## **APPENDIX N:**

# **Public Comment Letters on Draft Scoping Document and Draft Environmental Impact Statement (DEIS)**

# **Written Comments Received on Draft Scope**

# **PROPOSED MODIFICATION OF LOWER CONCOURSE REZONING**

**142 & 205 CANAL STREET WEST**  
 BETWEEN EAST 135TH AND EAST 138TH STREET  
 BRONX, NY  
 BLOCK: 2322, LOT: 28 & 71

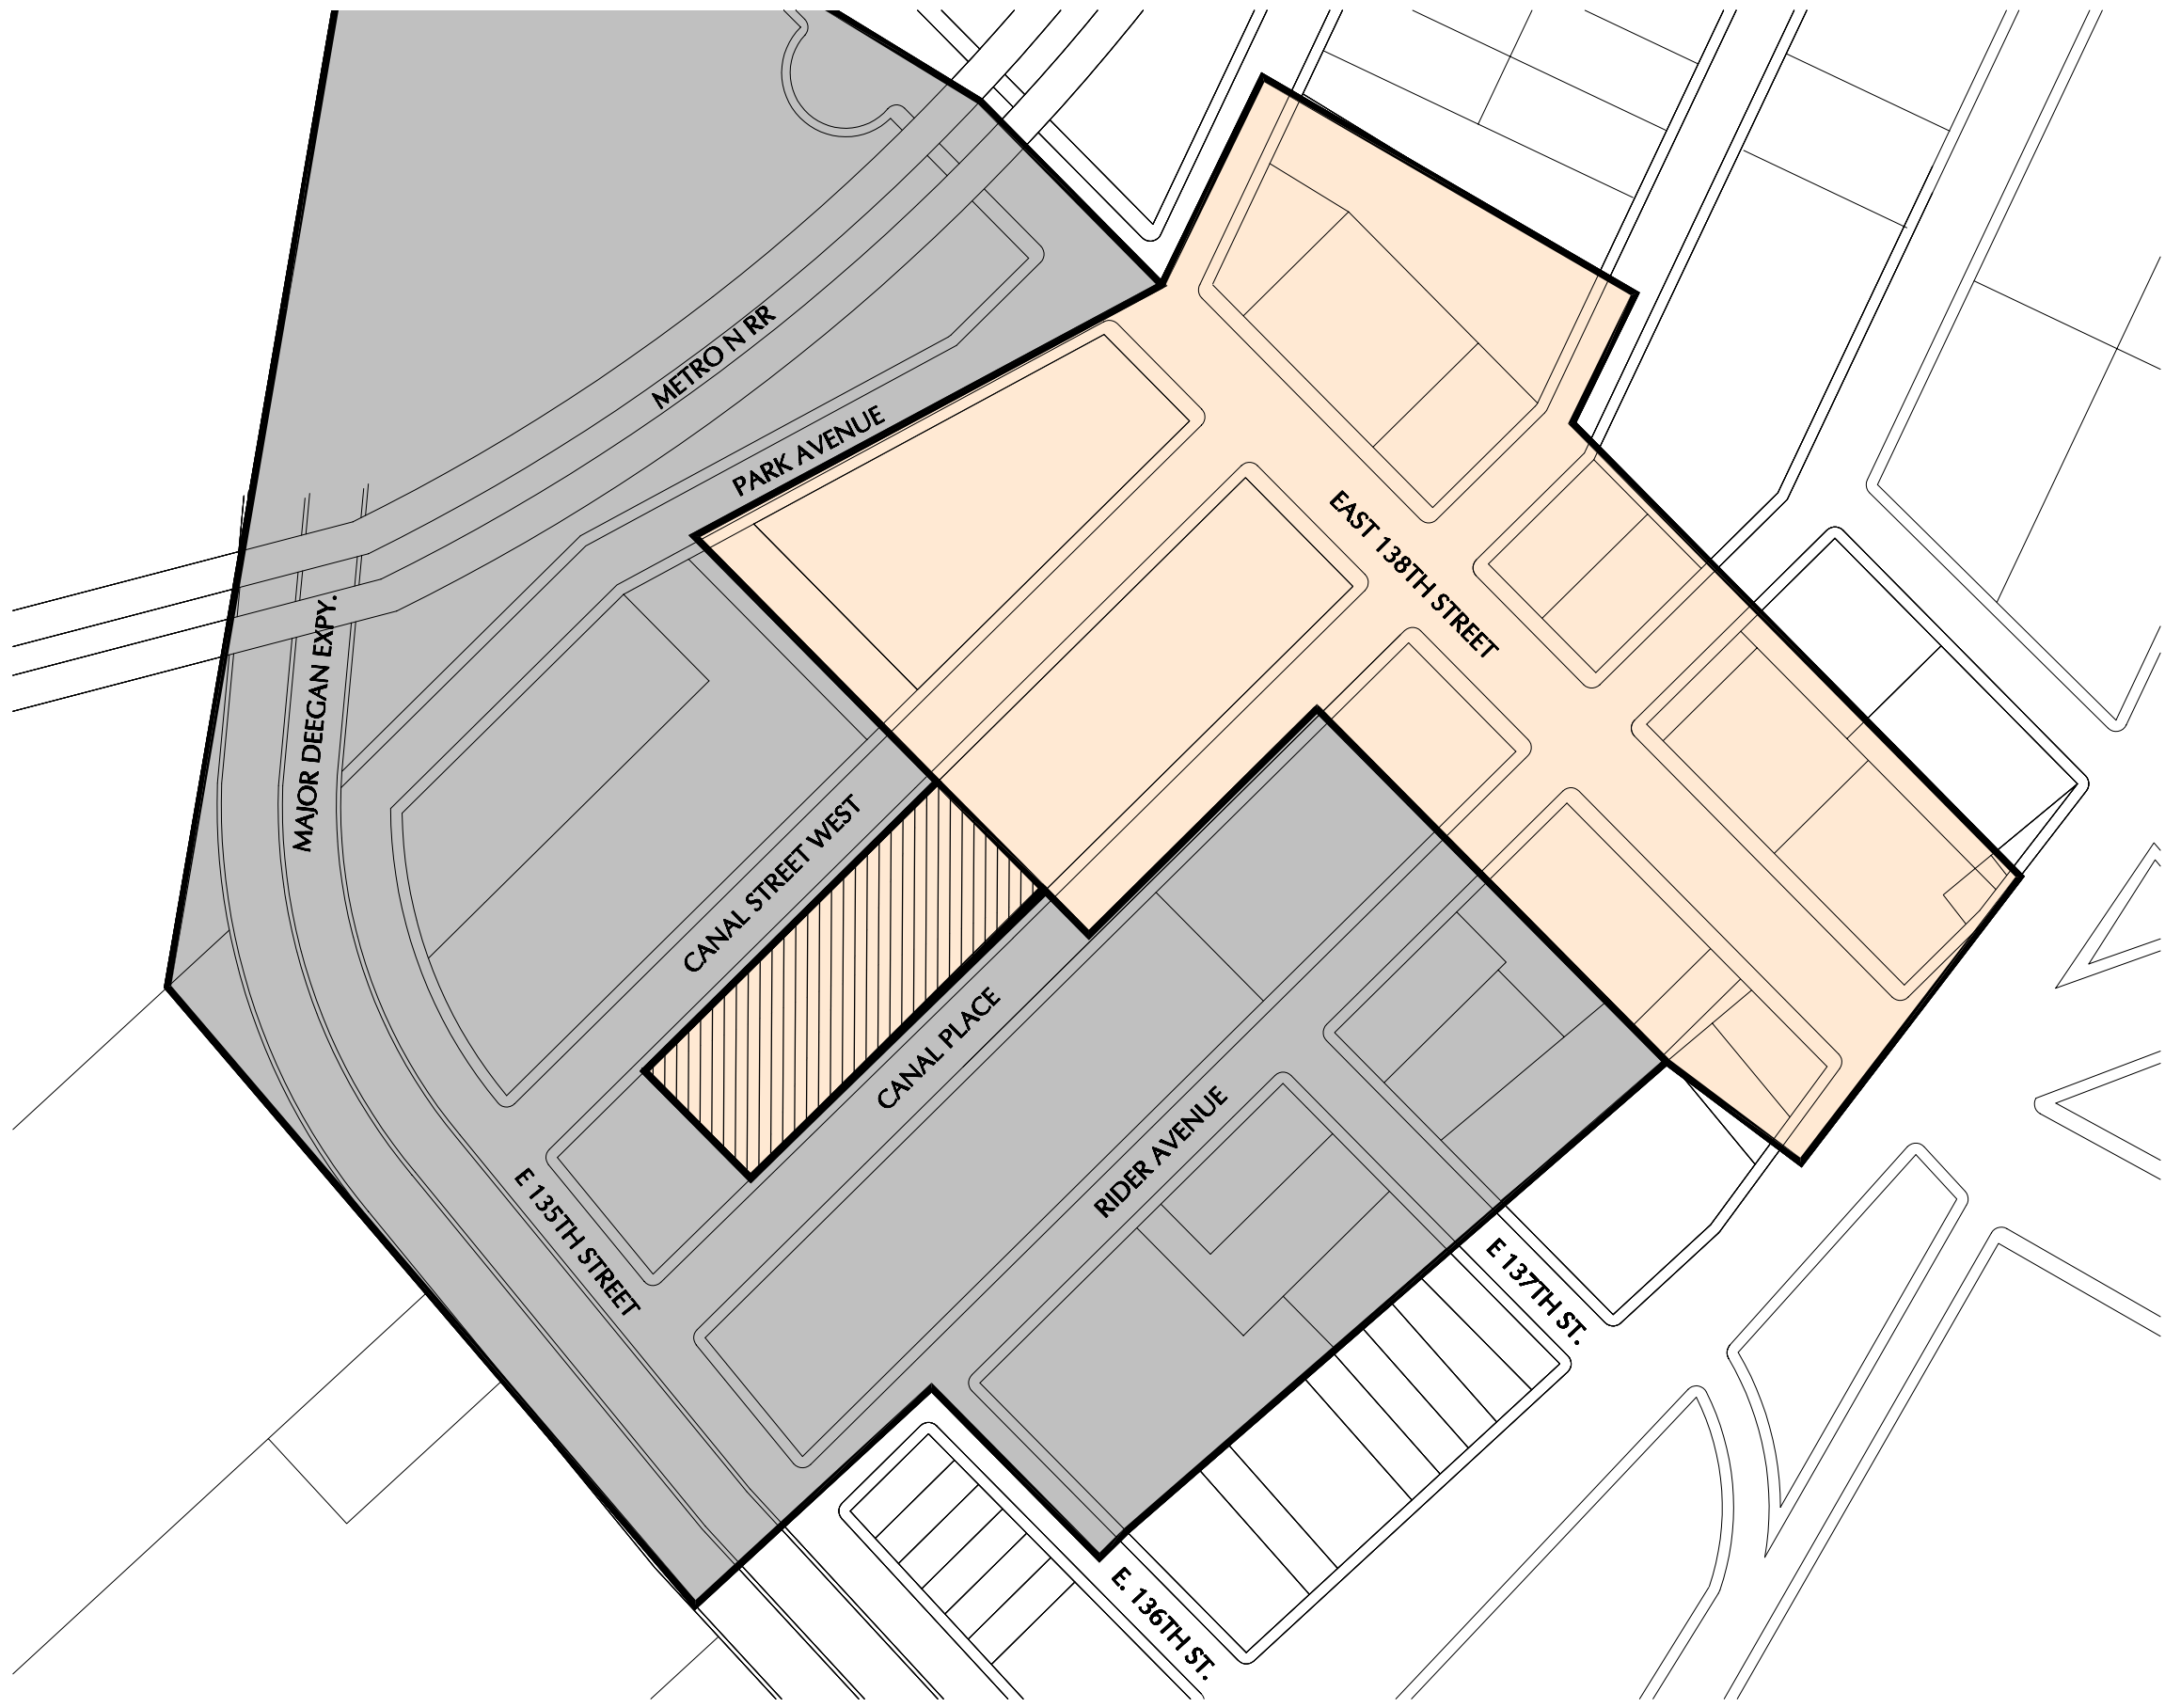
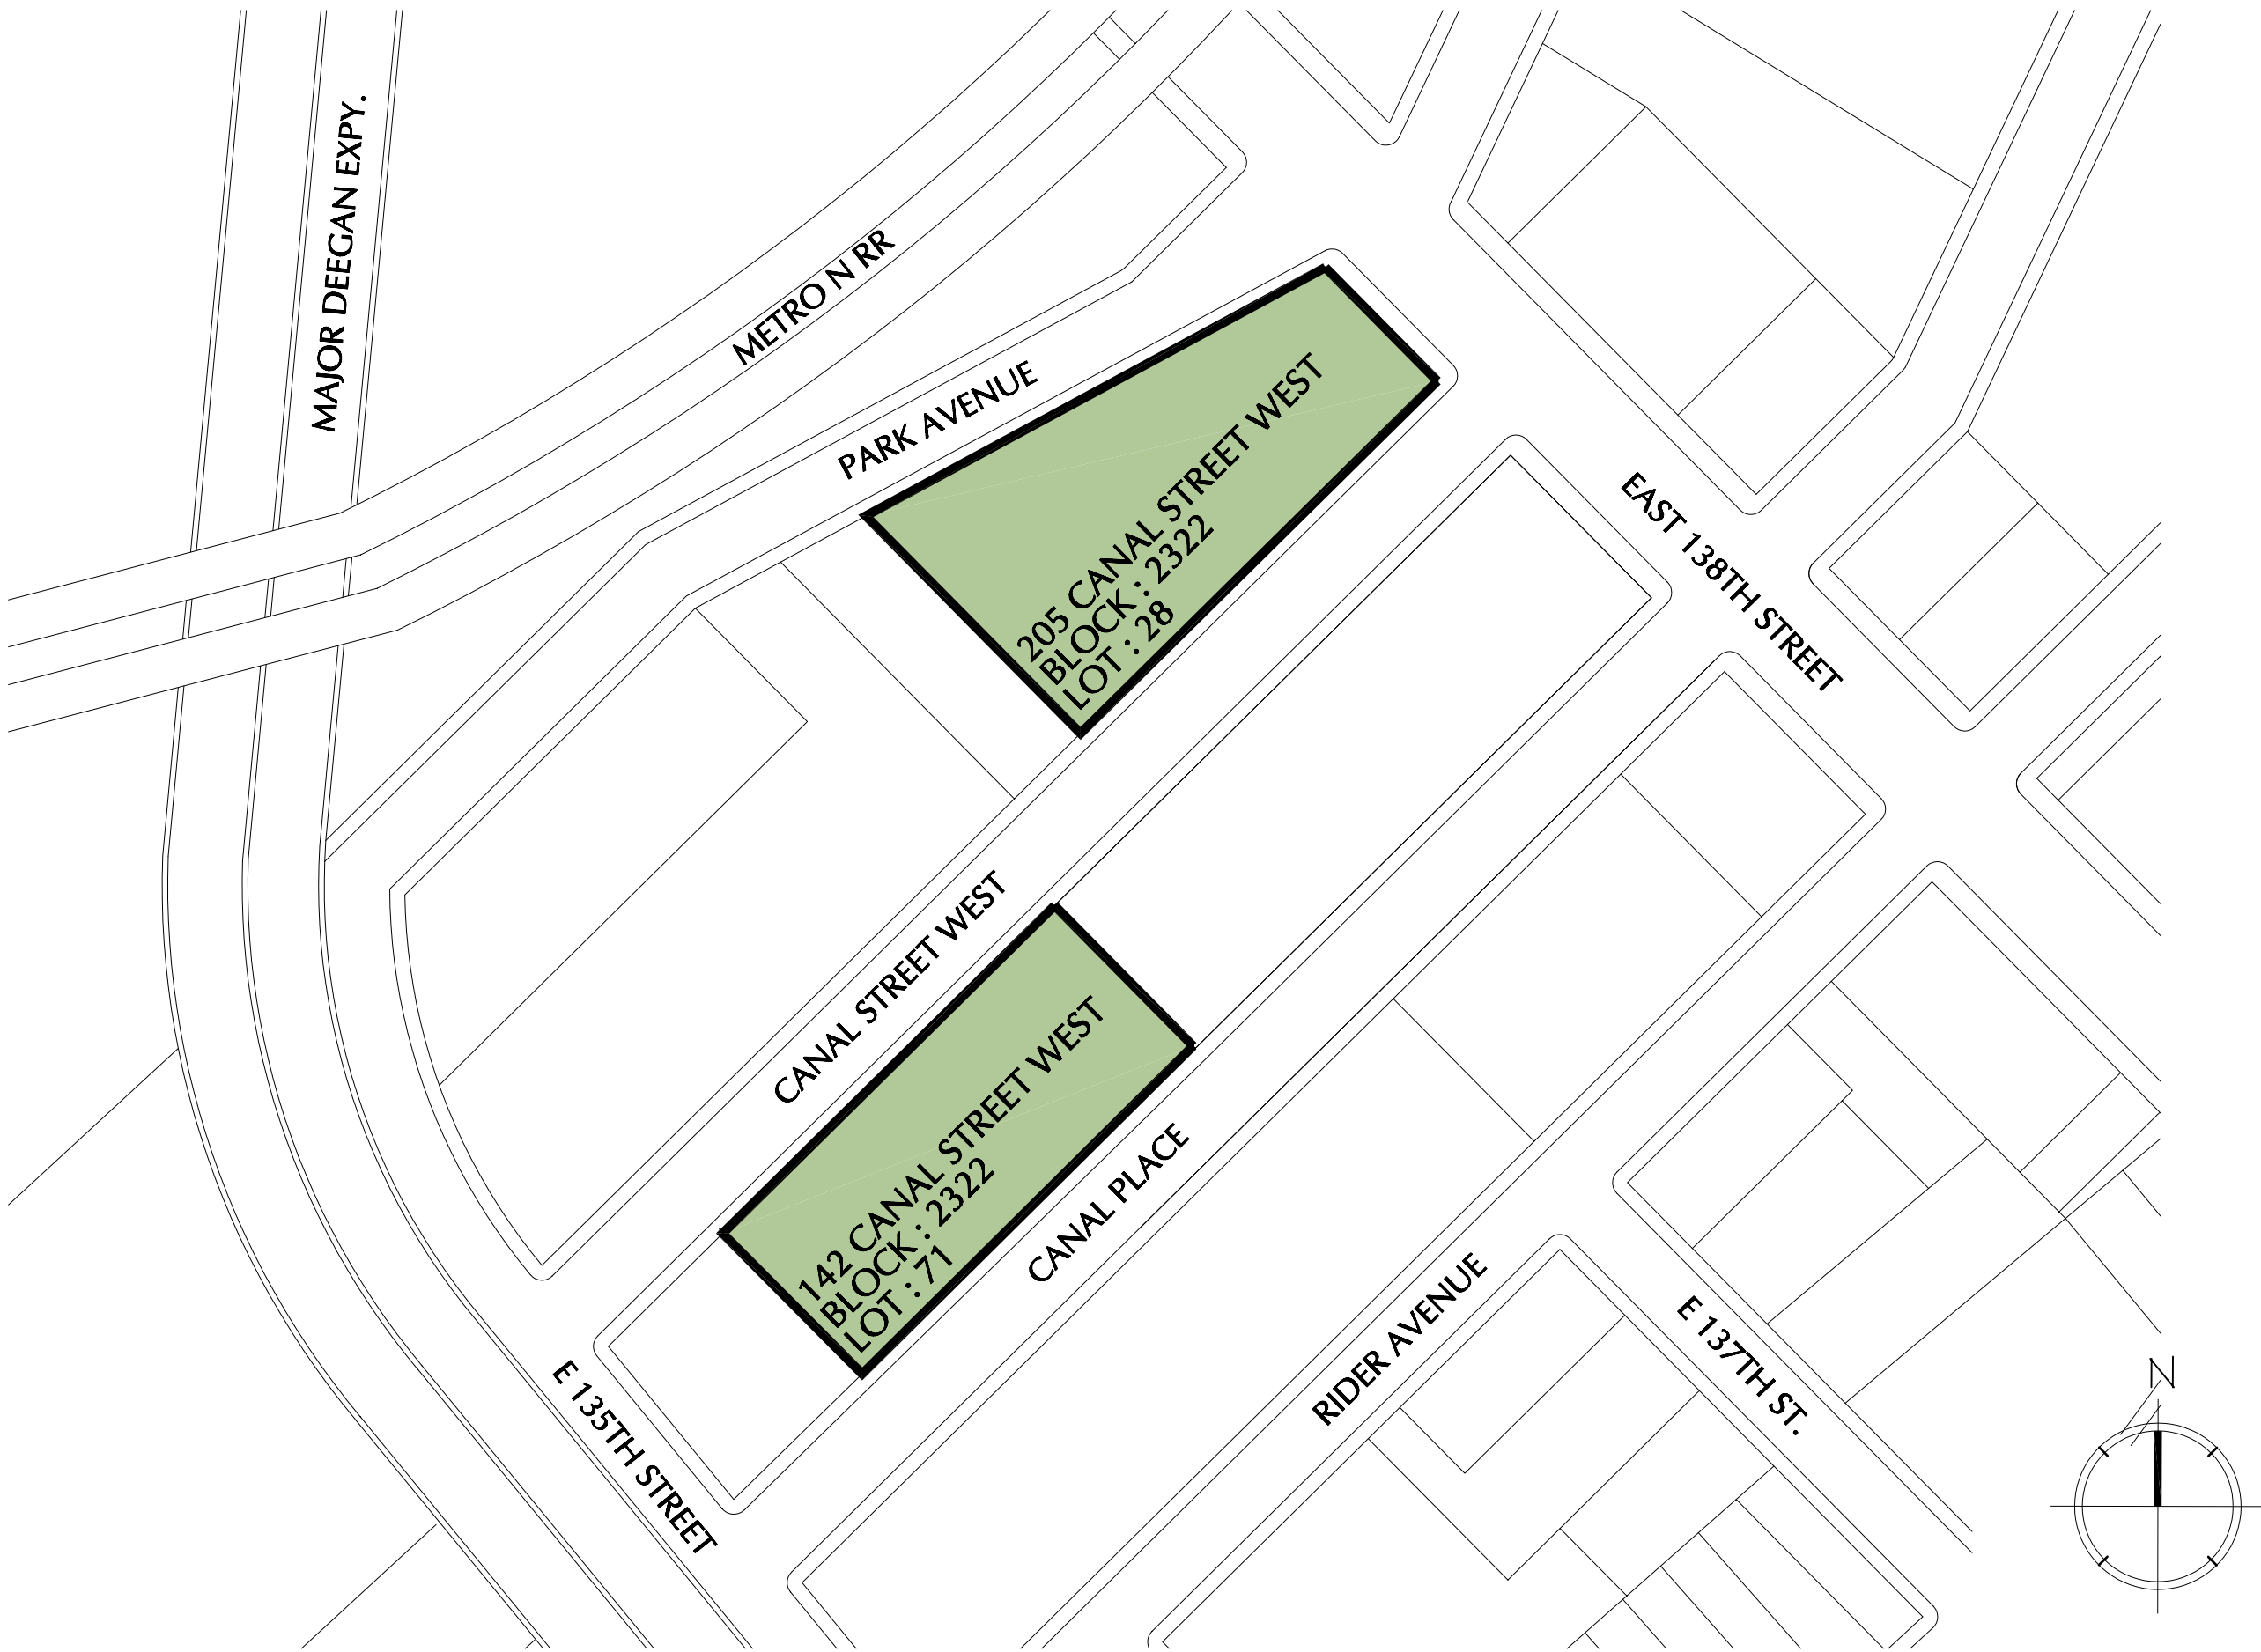
We support the Lower Concourse rezoning proposal, but we would like to propose a small modification. I represent the owner of 2 properties in the Lower Concourse area. One property is 205 Canal Street West, located between Park Avenue and Canal Street West at East 138<sup>th</sup> Street, and the second property is 142 Canal Street West, located mid-block between Canal Street West and Canal Place. The first parcel has been included in the proposed zoning action, while the second parcel has been excluded.

The owner assumed that both parcels were included in the rezoning and put together a plan for the development of both properties. Having only recently learned that the mid-block property was excluded from the rezoning they are now asking to have this parcel (142 Canal Street West) included in the adjacent MX: M1-4/R7X zone.

The manner in which this MX particular zone has been mapped is hardly a traditional corridor mapping since the zone extends to several mid-block parcels and extends as far as 300 feet southwest of East 138<sup>th</sup> Street between Park Avenue and Canal Place, as opposed to the normal 100 depth for corridor or avenue upzonings.

A stated goal of the rezoning is the re-use of underutilized industrial land. While both of the sites I'm discussing fit the profile of underutilized industrial land presenting housing opportunities – only one of the parcels was included in the rezoning proposal. The 300 foot distance from East 138<sup>th</sup> Street was possibly a “neat” place to draw the line due to the depth of our first property and the parcel adjacent to the second property

which fronts on East 138<sup>th</sup> Street. But we suggest that the planning goals and housing opportunities here are better served with a district boundary that includes the vacant mid-block site, a site very unlikely to be developed for conforming M1-4 uses. As projected, all proposed residential units will serve households earning less than 60% of AMI, and a portion of the units will serve households earning less than 50% of AMI.
